Access Compliance Report

Public Rights-of-Way

Intersection ID: 10024831	Main Street: DENMARK_RD	Cross Street: N/A	Location: E
ADA ID: E1B64BCEA15F	Ramp Type: Perp	Initial Pass/Fail: Fail	Overall Compliance: No
Severity Score: 25			
Codes/Mitigation Info/Possible Solution		Field Measurements/Component Compliance

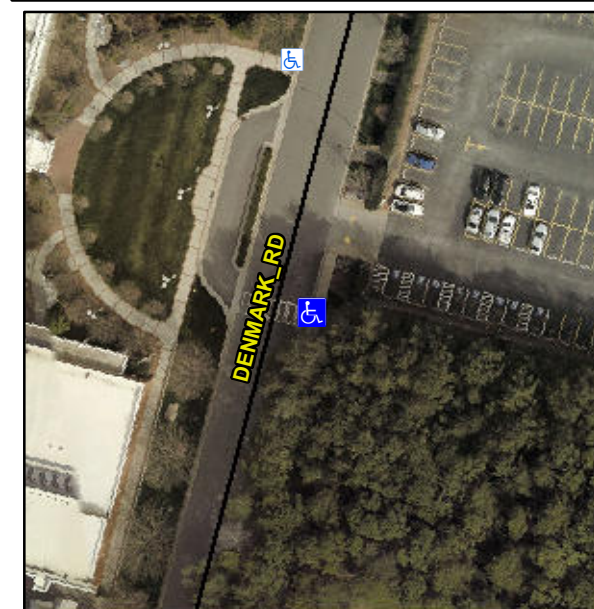
R304.2.2

Compliance	Description	Data	Compliance	Description	Data
N/A	Ramp Length (in)	61.0	No	Ramp Slope (%)	13.0
Yes	Ramp Width (in)	48.0	Yes	Ramp XSlope (%)	0.2
N/A	Flare Type LT	N/A	N/A	Flare Type RT	N/A
N/A	Flare Slope LT (%)	N/A	N/A	Flare Slope RT (%)	N/A
N/A	Flare Traversable LT?	N/A	N/A	Flare Traversable RT?	N/A
N/A	Landing Length (in)	N/A	N/A	DWS Provided?	N/A
N/A	Landing Width (in)	N/A	N/A	DWS Contrast?	N/A
N/A	Landing Slope (%)	N/A	N/A	DWS Length (in)	N/A
N/A	Landing X Slope (%)	N/A	N/A	DWS Full Width?	N/A
N/A	Landing Curb? (Y/N)	N/A	N/A	DWS Offset (in)	N/A
N/A	Shared Landing?	N/A			
N/A	Gutter Ponding?	N/A	N/A	Gutter Slope (%)	N/A
N/A	Gutter Lip Ht (in)	N/A	N/A	Gutter X Slope (%)	N/A
N/A	Painted X Walk1?	Yes	N/A	Painted X Walk2?	N/A
	X Walk 1 Direction	To W		X Walk 2 Direction	N/A
N/A	X Walk 1 Width (in)	113.0	N/A	X Walk 2 Width (in)	N/A
	X Walk 1 Slope (%)	5.5		X Walk 2 Slope (%)	N/A
	X Walk 1 X Slope (%)	0.4		X Walk 2 X Slope (%)	N/A

Remove & Replace Entire Ramp.
